### ADDENDUM NO. 1 - OUTLINE AND SUMMARY INFORMATION

Project Name: MSU Stadium Lots

PPA No.: 22-0012

Date: 03-27-2024

SHEET  
**CD1.4**

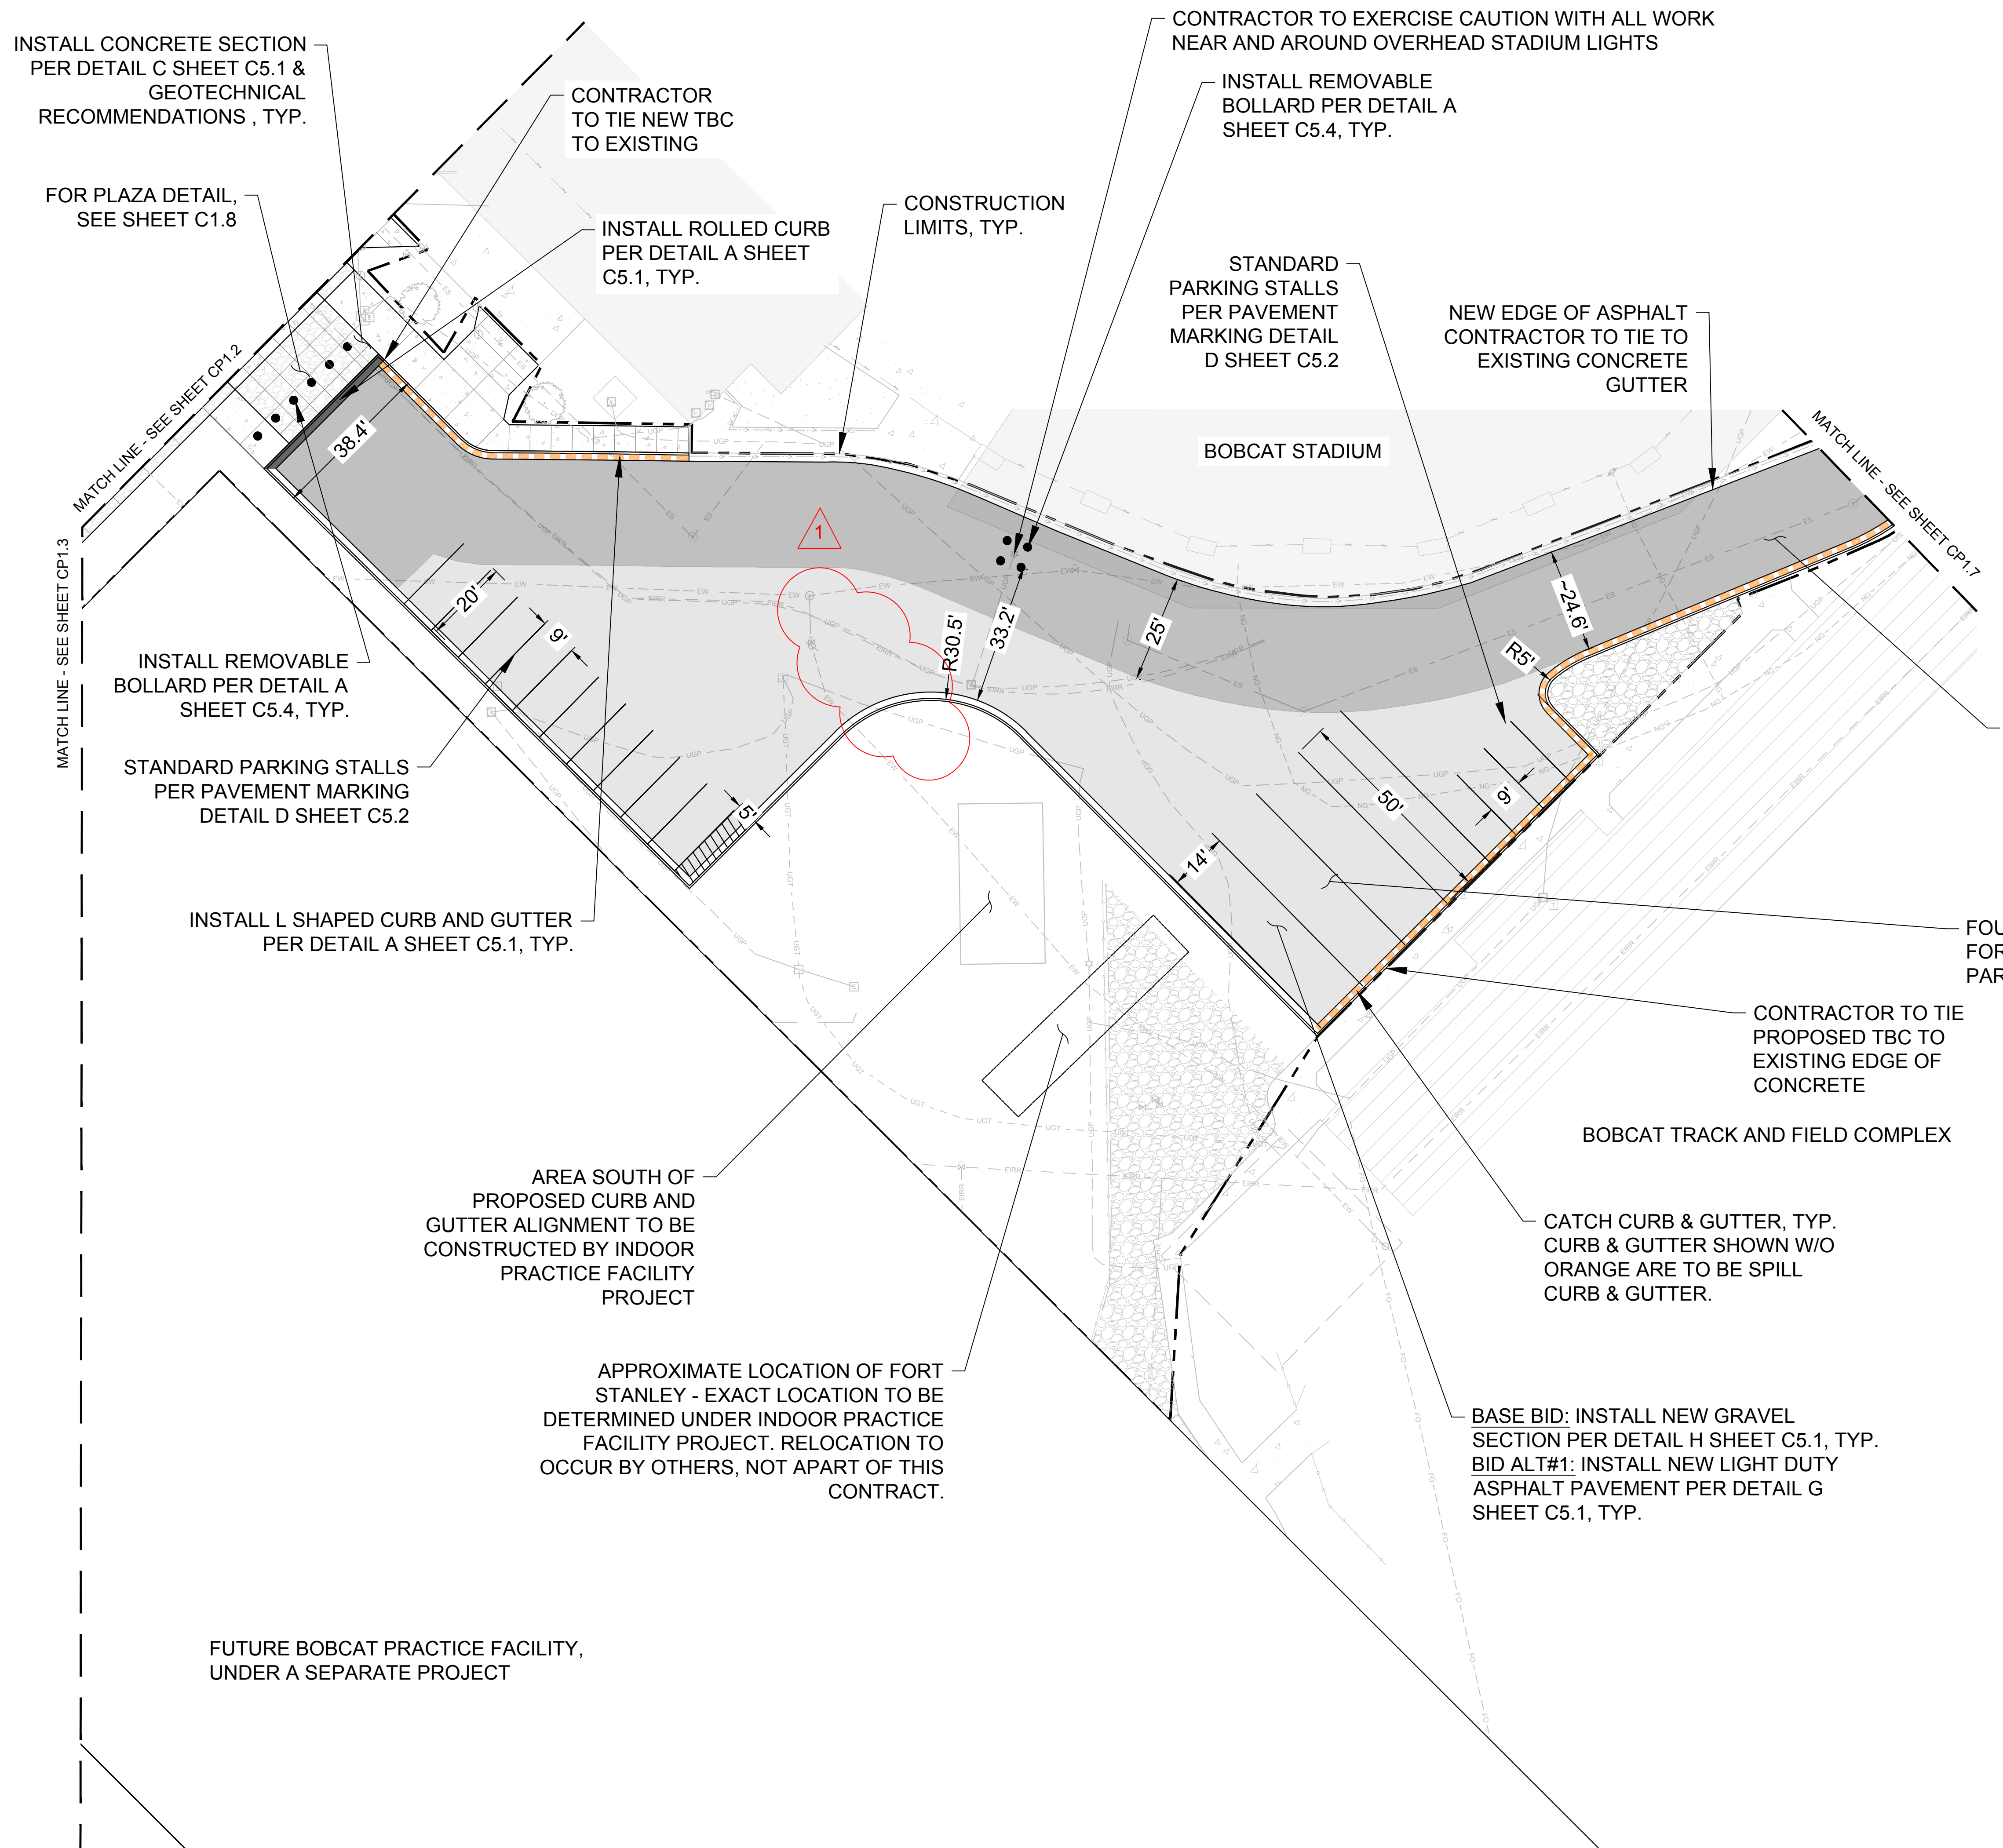
- A. REVISE - REMOVAL AND REPLACEMENT OF EXISTING HYDRANT: The removal and relocation of the existing hydrant shown on this sheet is no longer a part of this scope of work. Instead, this specific hydrant will be removed and relocated under the indoor practice facility project.

1  
REMOVAL AND RELOCATION OF EXISTING HYDRANT ASSEMBLY & BOLLARDS TO BE DONE BY INDOOR PRACTICE FACILITY CONTRACTOR.

SHEET  
**CU1.1**

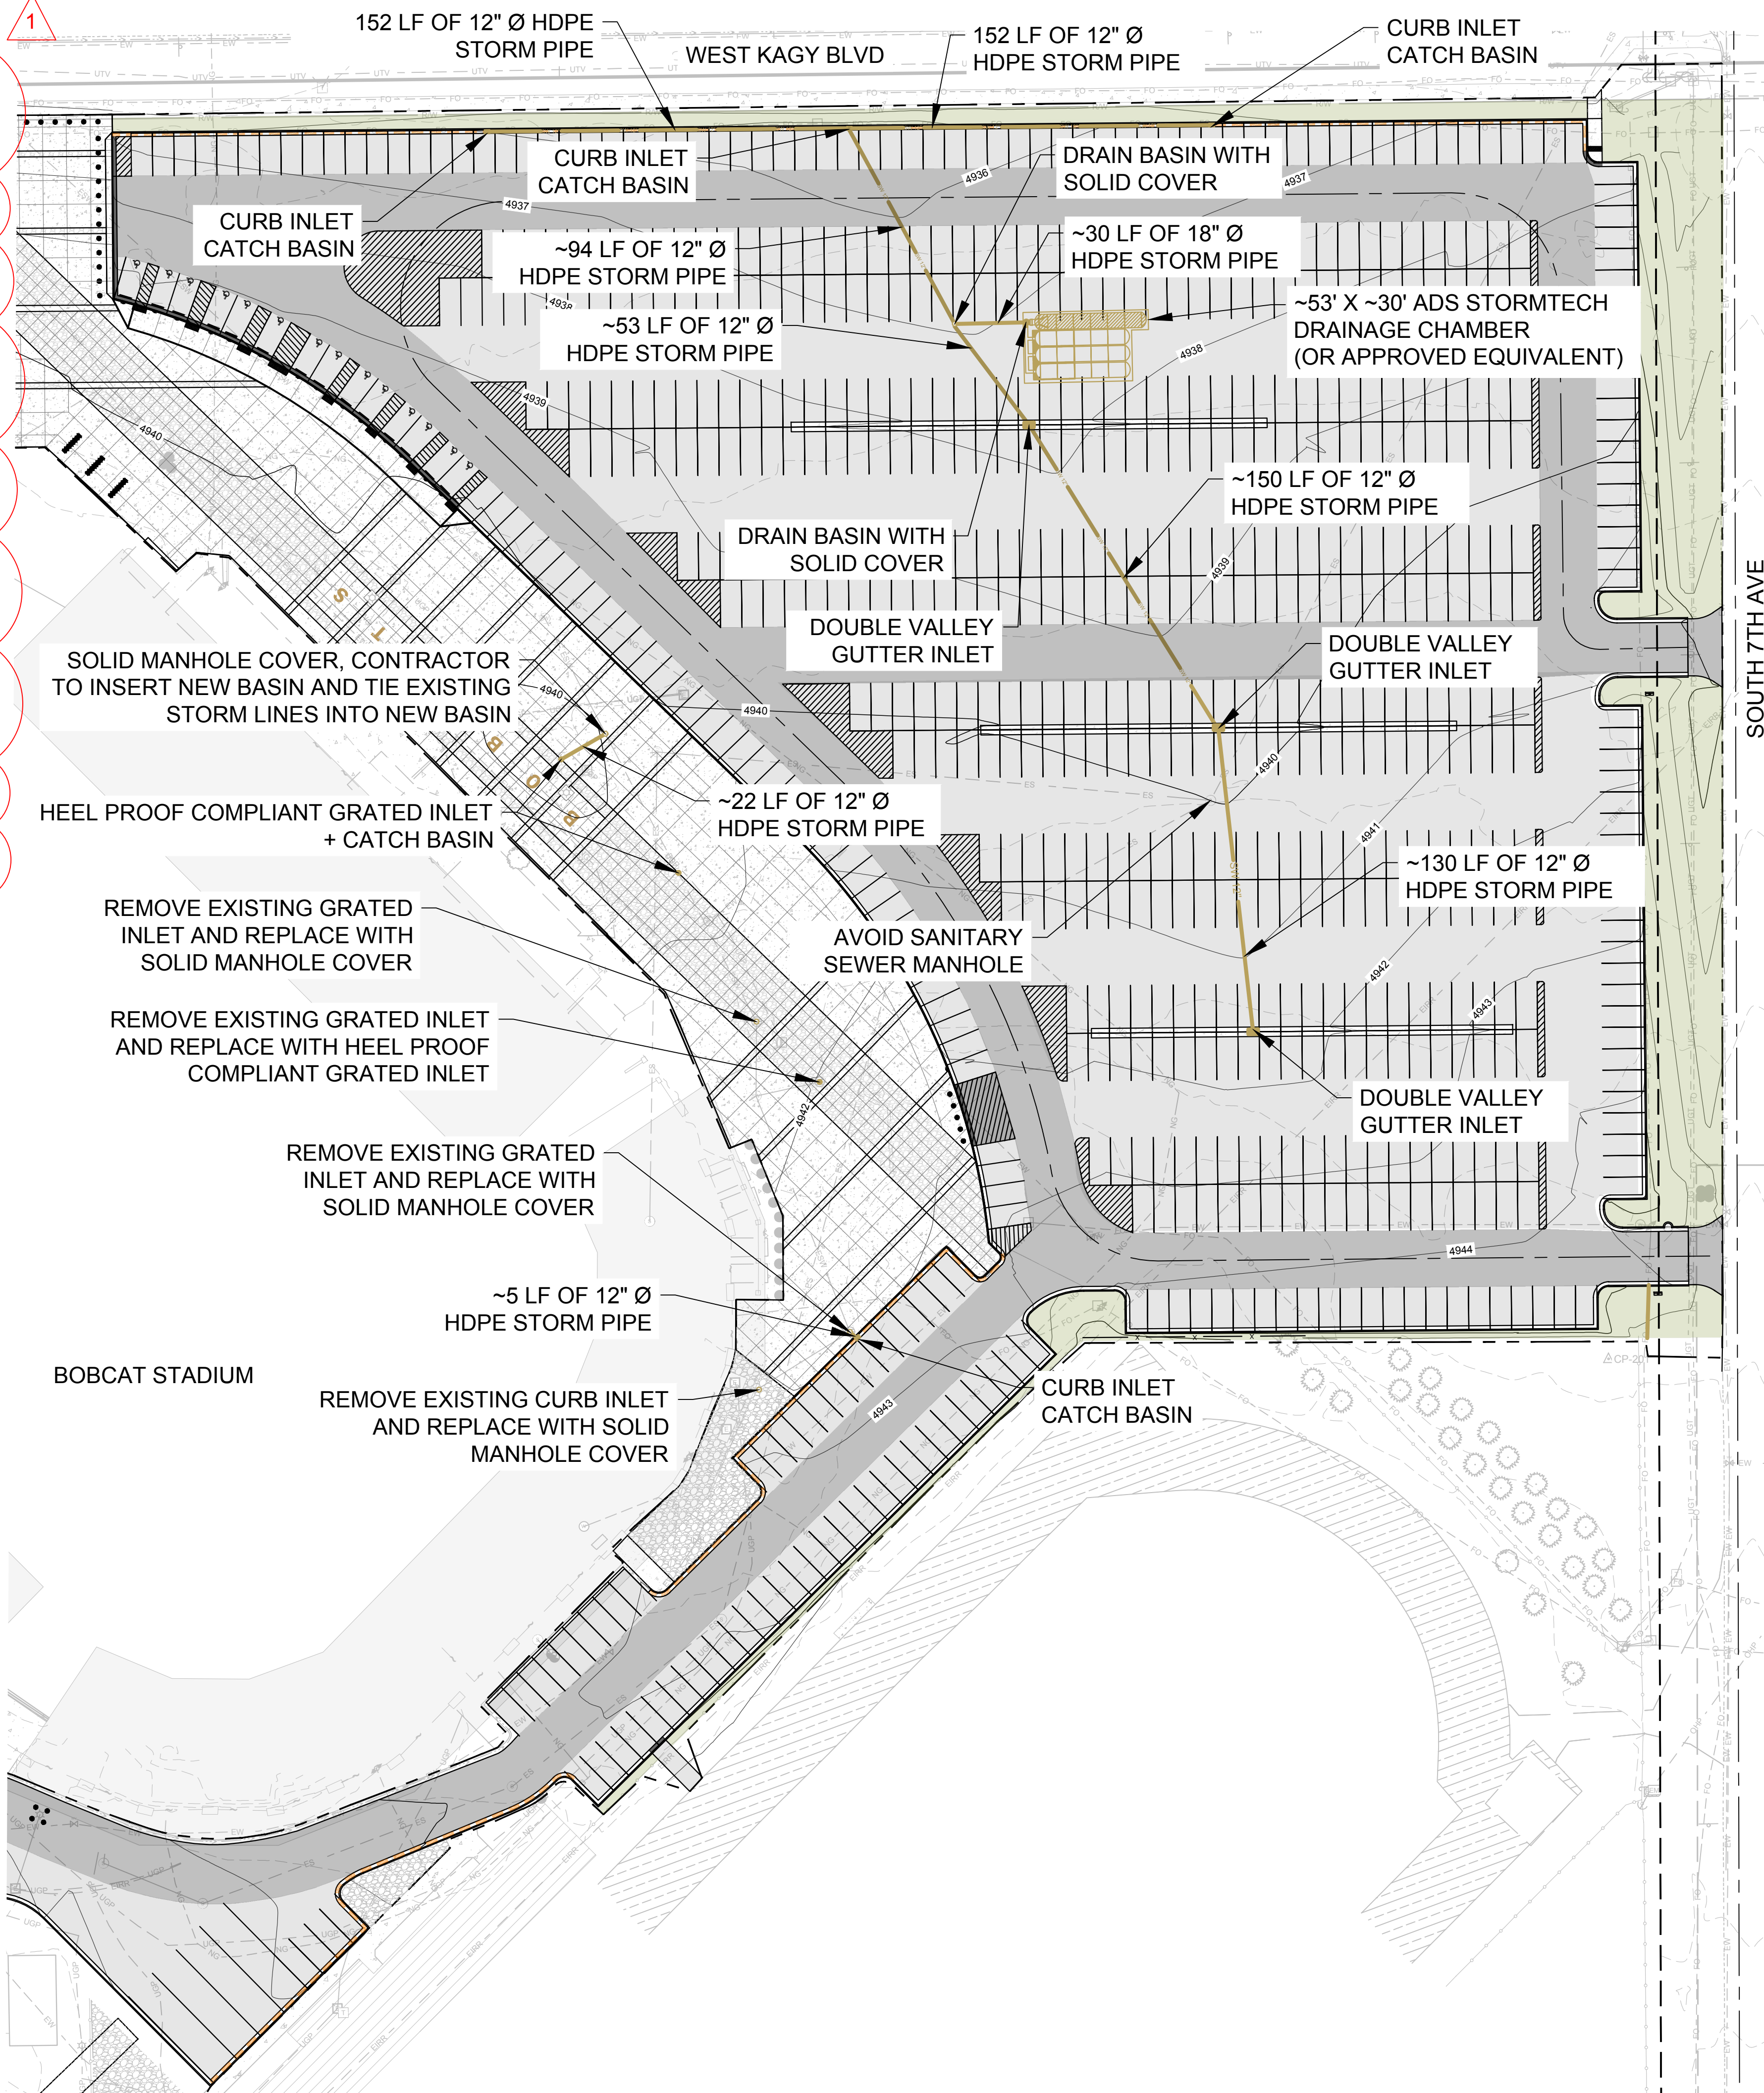
- A. ADD – GENERAL NOTE: General note #6 was added to provide the contractor with further clarification on tying into existing storm infrastructure.

SHEET  
**CU1.2**

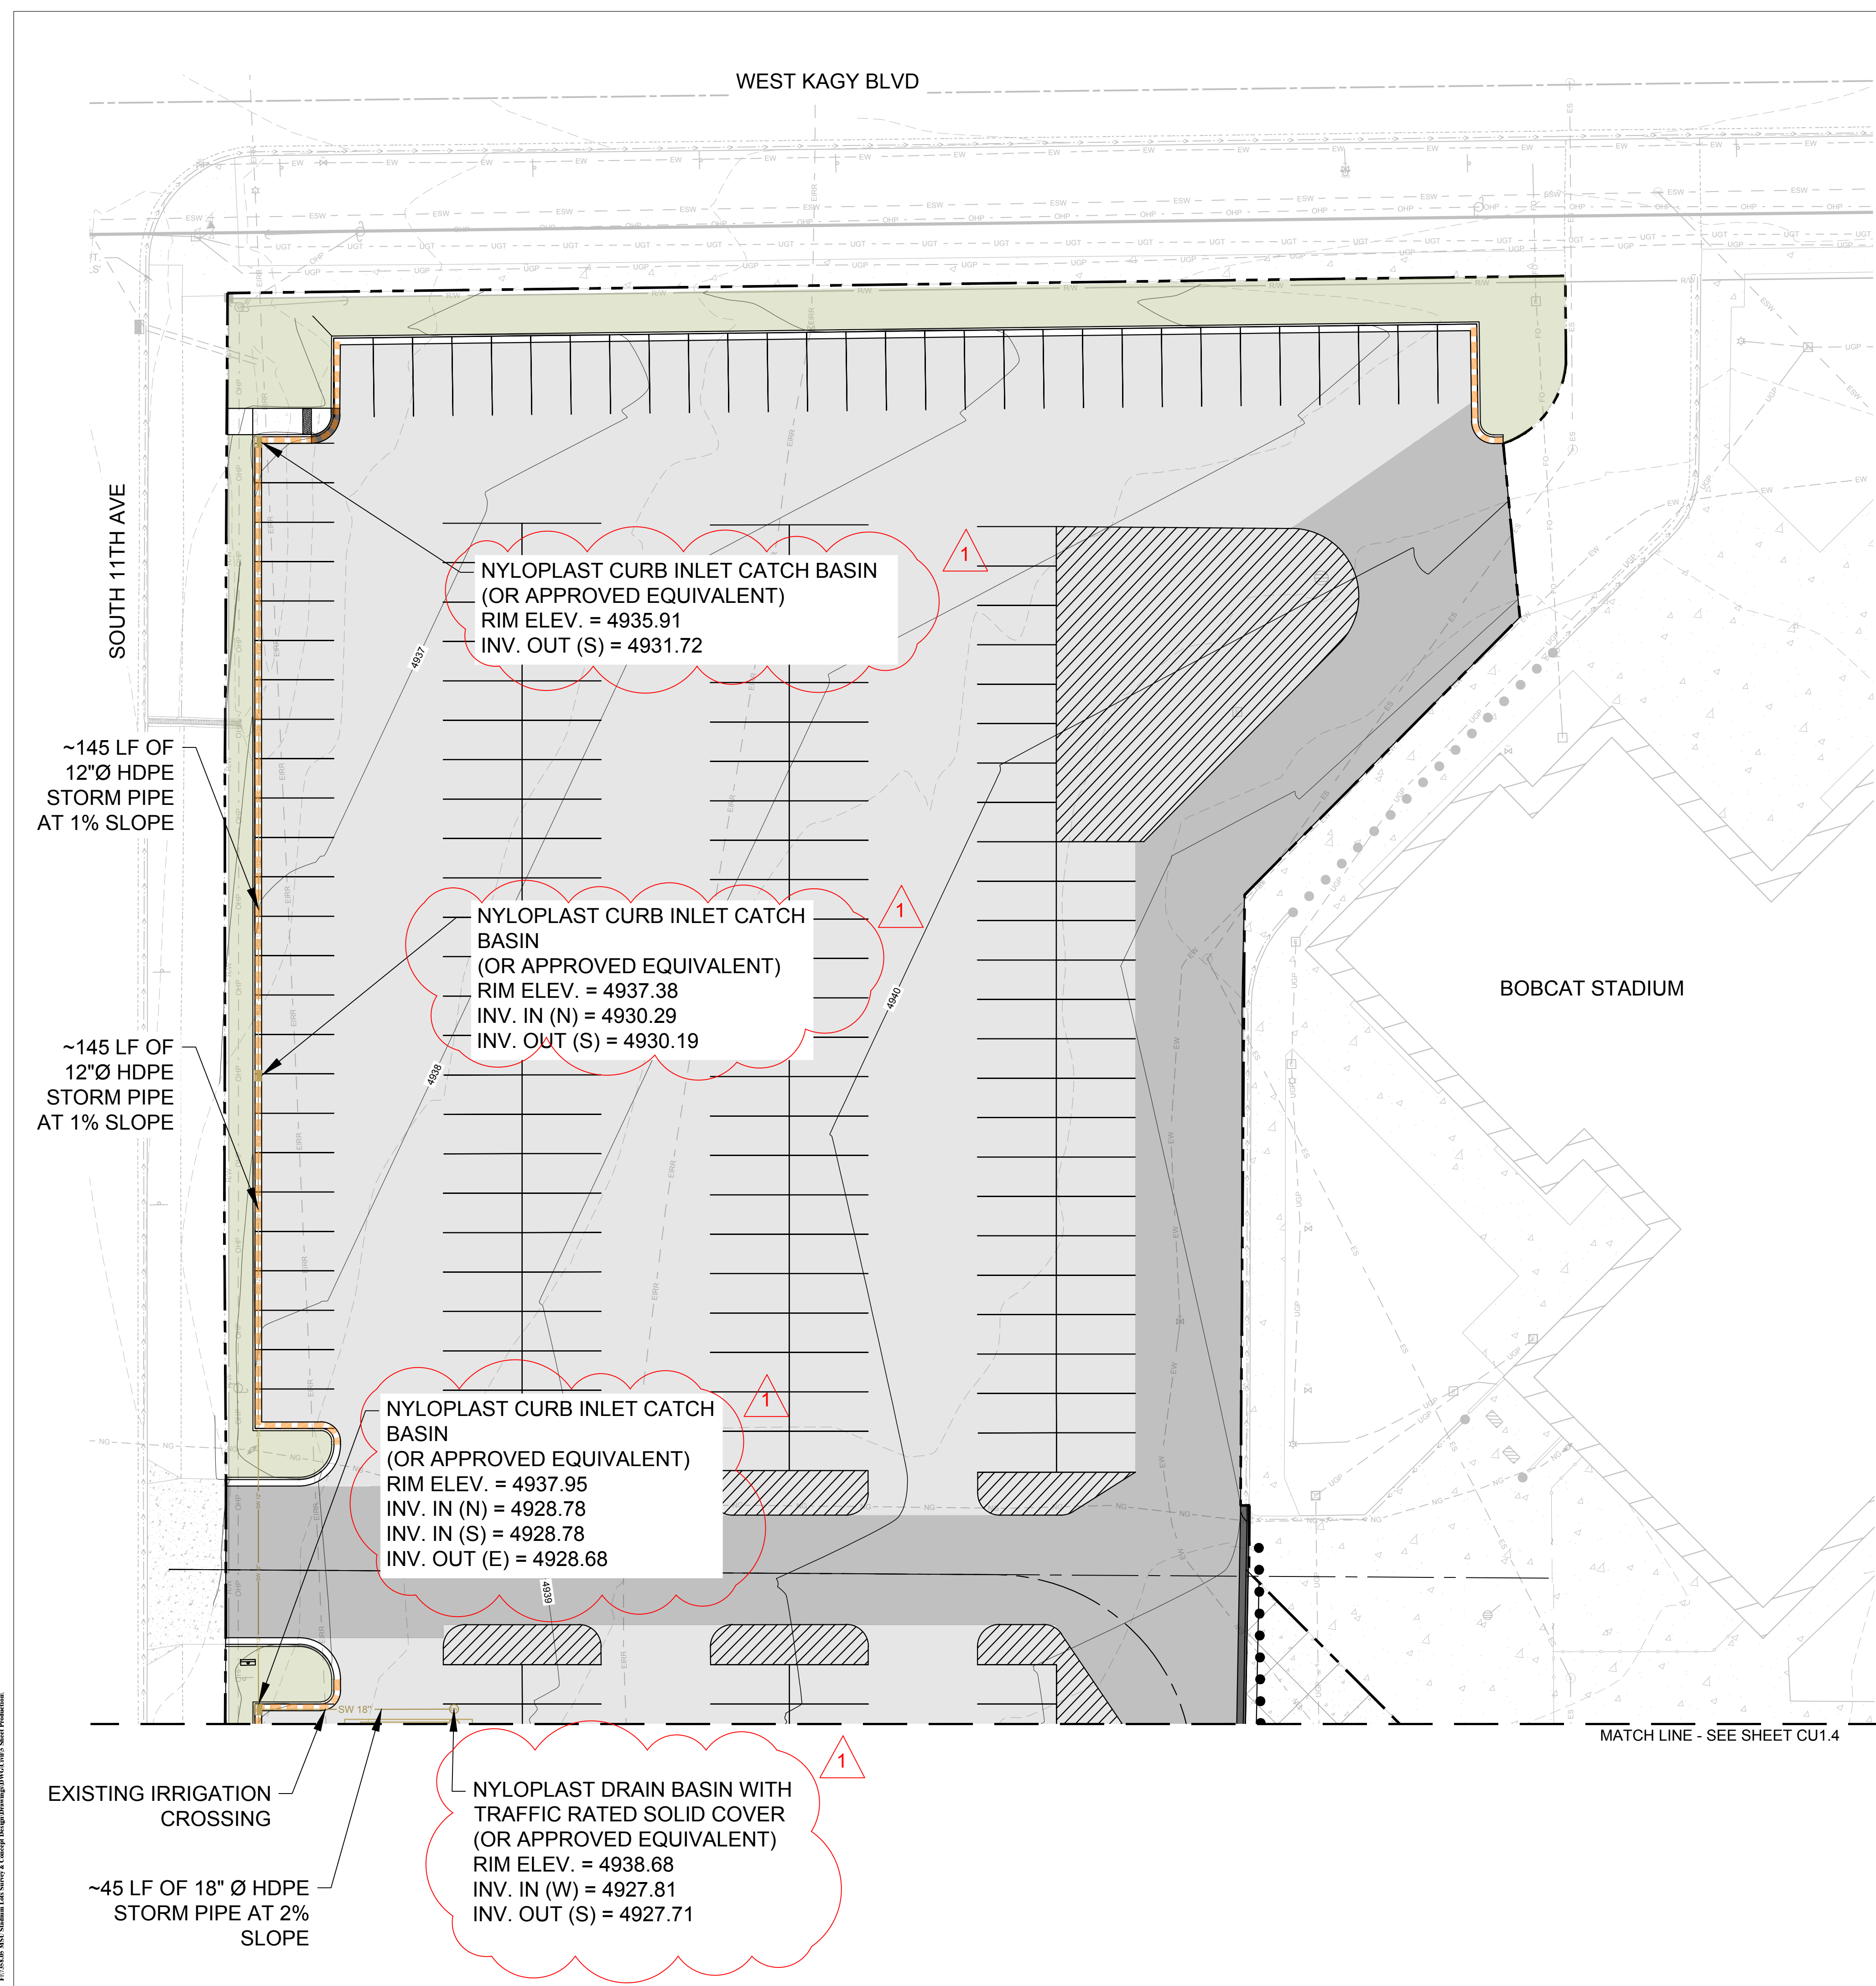
- A. ADD - GENERAL NOTE: General note #6 was added to provide the contractor with further clarification on tying into existing storm infrastructure.
